# West Burton Solar Project

### Figure 8.18.1: Landscape and Ecology Mitigation and Enhancement Measures West Burton 1

### Revision A

Document reference: ~~APPEX1~~WB6.4.8.18.1\_A

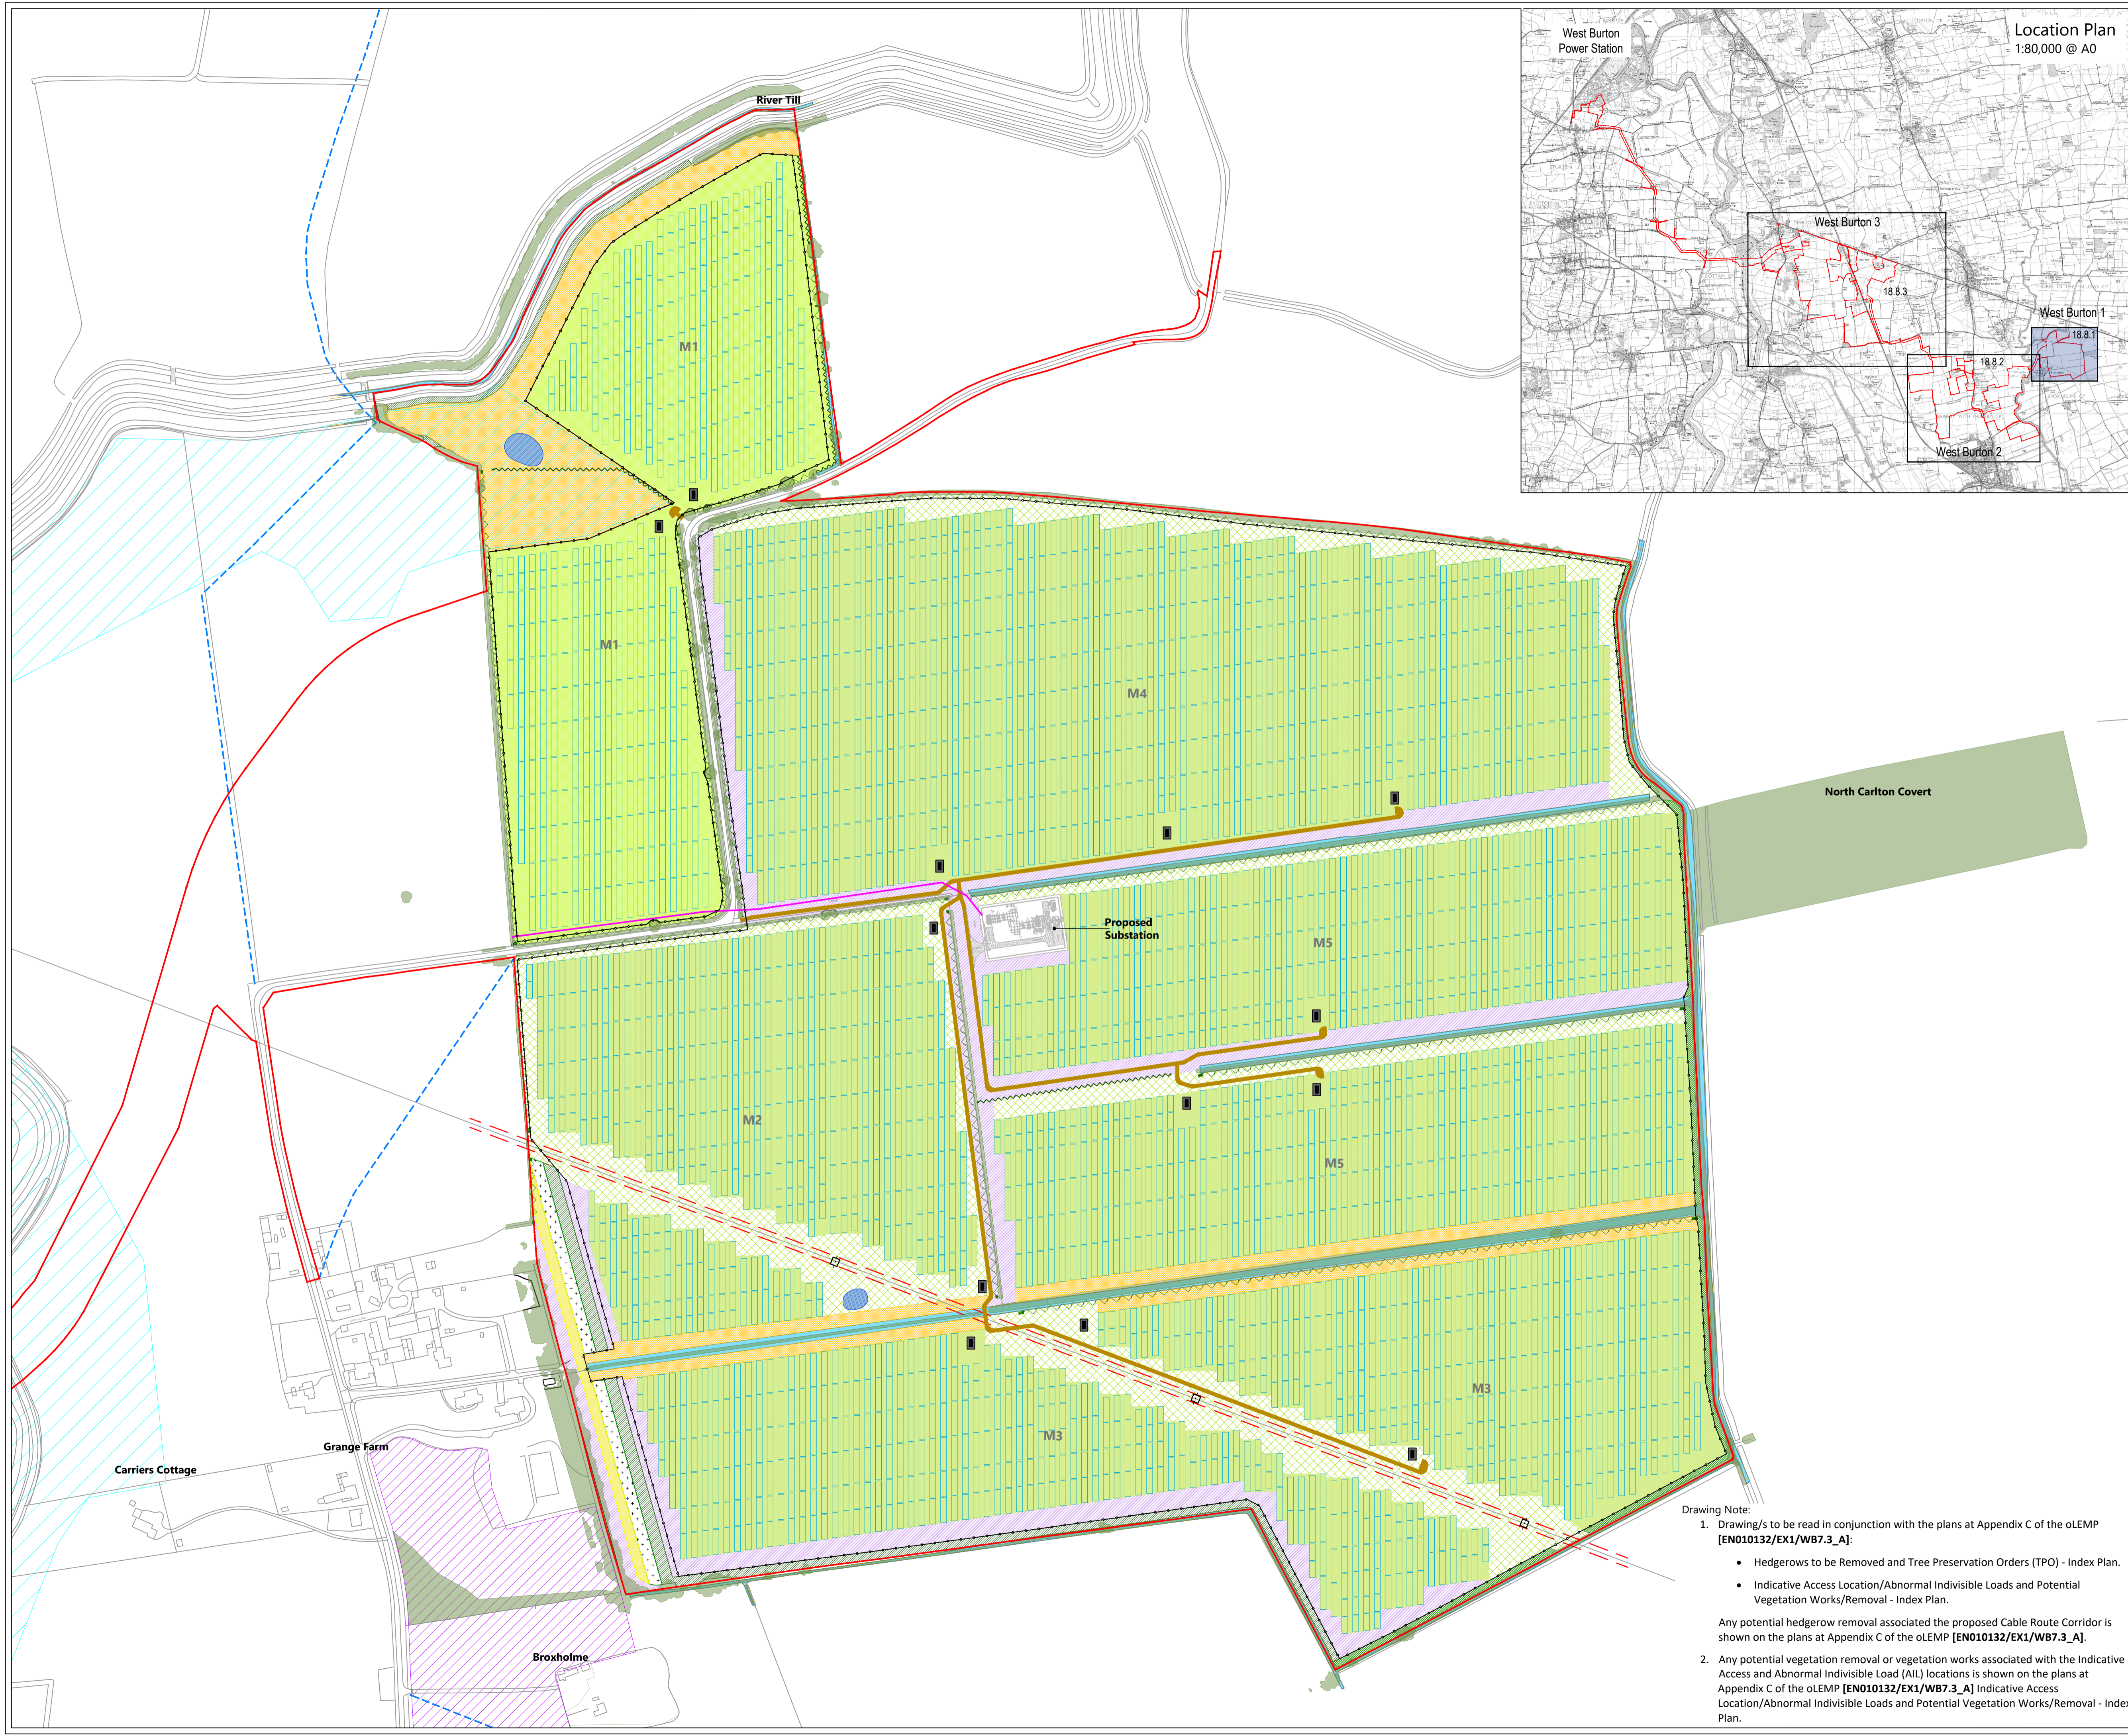
Figure Reference	Page	Description of Changes	Reason for Revision
<a href="#">WB6.4.8.18.1_A</a>	<a href="#">3</a>	<p><a href="#">Change to spelling of 'enhancement'.</a></p> <p><a href="#">Amend the wording of hedgerow removal in the key from 'Existing hedge to be removed' to 'Existing hedge to be removed permanently'.</a></p> <p><a href="#">Offset calculations from drains.</a></p> <p><a href="#">Changes to hedgerow removal locations.</a></p> <p><a href="#">Changes to proposed woodland planting.</a></p>	<p><a href="#">To correct a typo.</a></p> <p><a href="#">For clarity.</a></p> <p><a href="#">For clarity.s</a></p> <p><a href="#">For clarity.</a></p> <p><a href="#">In response to changes to proposed cable route and tracks</a></p>
